BORR Northern and Central Response to Public Submissions on ARI

BORR-01-RP-EN-0020

Rev 1

April 2020

(WRP habitat on left (EMP Figure 2 [4 of 5]))

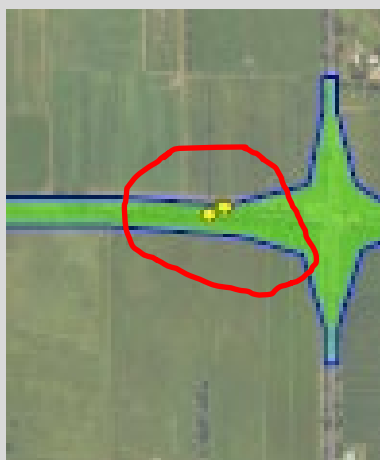
Item No.	EPA Services Comments
2	<p><u>Viability of fragmented habitat patches remaining</u></p> <p>Page 53 of the ARI document states; “all WRP habitat areas within the Proposal Area are contiguous with or adjacent to other habitat areas that will be retained”. The proponent is relying on the assumption that WRP will self-relocate to adjacent areas of retained habitat ahead of clearing (ARI document, pg 56). However, there are some locations where individual WRP have been recorded in habitat that appears already isolated and self-relocation will not be possible (e.g. Appendix B, Figure 2 [page 5 of 5]). See examples as follows:</p> <p>The patch of habitat with WRP observations (central section of BORR proposal south of Manea Park and west of South West Hwy; Figure 7 [5 of 5]) is isolated from adjacent consolidated vegetation.</p> <ol style="list-style-type: none"> Should the pre-clearing surveys identify a possum(s) in this patch, provide further information to demonstrate that the shepherding technique is appropriate in this circumstance rather than translocation? Also, as approximately 60% of the patch of vegetation is proposed to be cleared, what information is available to support the conclusion that the remaining portion of vegetation will remain viable support WRPs.

WRP populations within a given area of habitat fluctuate seasonally. The maximum seasonal WRP population provides an indication of the year round WRP population an area of habitat is capable of sustaining (pers comm., Ms. Barbara Jones). Based on this advice and all information obtained through studies and consultation conducted for the Proposal, shepherding WRP into adjacent habitat areas during clearing is considered the optimal approach in regard to WRP welfare and is favoured over translocation. In addition, management provisions including timing clearing operations to occur outside of the population peak (spring and early summer) wherever possible if densities are high at the time of clearing, will ensure that adjacent habitat is capable of sustaining any existing resident individuals as well as dispersing individuals.

The specific patch noted south of Manea Park and west of South West Hwy is an existing degraded and isolated patch which still supports WRP and does connect to similar and larger patches of habitat to the east between Centenary Road and Lilydale Road, even taking into account the footprint of the future proposed BORR South Segment. The patch circled will still be larger than the isolated patched and trees immediately south of Centenary Road within which WRP have been recently observed (Figure 6, Appendix A of the Additional Information) and will have connectivity to surrounding habitat to the east of the proposal.

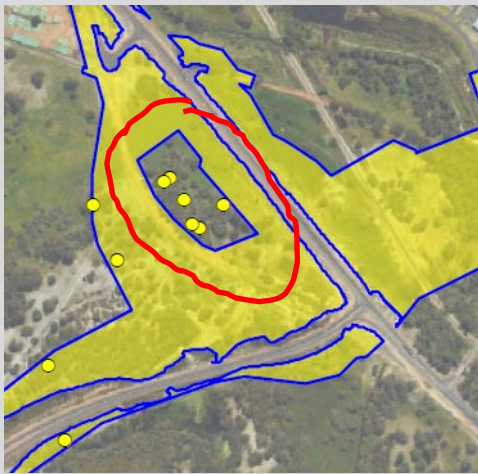
Item No.	EMP Section No.	EPA Services Comments
3	Table 5 on p.10	<p><u>MRWA "Sensitive clearing protocols":</u></p> <p>The management action in Table 5 on p.10 states:</p> <p><i>Trees [...] that are observed to support WRP and / or BTP after 48 hours will be 'bumped gently' with a machine prior to felling. The operator and spotter will wait and observe the tree for a short time. If the animal remains in the tree it shall be pushed over slowly onto vegetation within the clearing area that is yet to be cleared. The 'soft felling' of habitat trees will provide a 'cushion' for the vegetation being felled, minimising the risk of injury to the animal and allowing any WRP and BTP present with the opportunity to safely vacate.</i></p> <ul style="list-style-type: none"> • Are there other actions that can be implemented if/when this circumstance arises? • Are you considering trapping and relocation of individuals an option for fauna unable to safely self-relocate ahead of clearing? <p>Is this method intended for identification of black cockatoo nesting, and if so, can an alternative be used?</p>

Prior to clearing, accessible vacant dreys will be removed and accessible tree hollows suitable for possums will either be removed or blocked. Immediately prior to and during clearing works inspections for resident fauna in tree hollows, including Black Cockatoos, will be conducted. Should any WRP or BTP be present, the tree will be left for 48 hours to allow the animal to vacate. If the tree continues to be occupied after 48 hours, the animal will be coerced / moved to a safe area outside of the clearing footprint by the appointed zoologist / environmental scientist / fauna spotter.

Implementation of this sequential series of proposed actions is expected to make it highly unlikely that any tree needs to be 'bumped' as described. As such, no additional actions are proposed should this circumstance arise.

Photo Point 1: Treendale Road western patch looking east (note only one *Xanthorrhoea preissii* was observed within either Treendale Road patch)

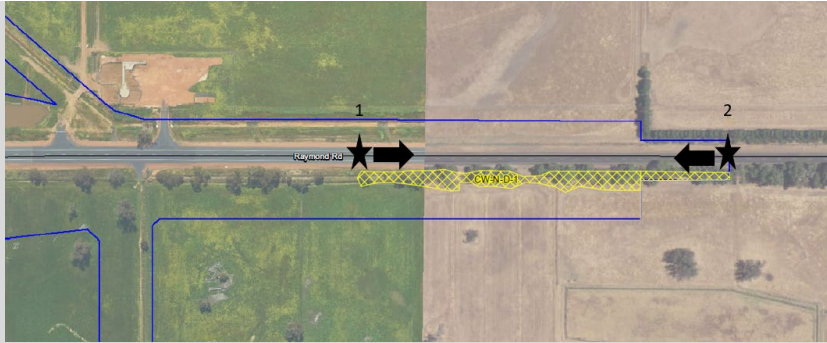
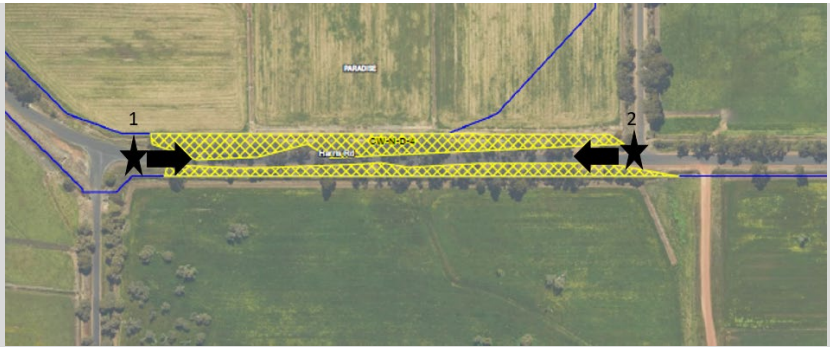
Item No.	EPA Services Comments
1	<p>EPA Services advise that an additional offset is required to counterbalance all impacts to <i>Corymbia calophylla</i> – <i>Xanthorrhoea preissii</i> woodlands and shrublands of the SCP (FCT3c) TEC.</p> <p>While the FCT3c TEC occurrences proposed to be cleared are considered small, narrow, isolated and mostly degraded (with the exception of 0.015 ha which is mapped as good or better condition and connected a larger remnant), DBCA have advised that only 12 ha remains of this TEC in the south west. In this context, EPA Services considers that cumulative impact to this TEC is already at a critical level, and that all impacts to this TEC should be offset.</p>

Therefore, if impacts to this TEC cannot be avoided, Main Roads should include an offset to counterbalance the direct impact of 1.3 ha of FCT3c TEC, noting that DBCA's advice indicates that appropriate management should be implemented to ensure indirect impacts area avoided.

With regards to the 12 ha of this community that occurs within the south west, Main Roads is uncertain where DBCA has recorded these areas or whether they are on lands managed for conservation purposes. Limited information has been published on this community type since the 2000-2003 Interim Recover Plan was released in 2000 (English & Blyth, 2000).
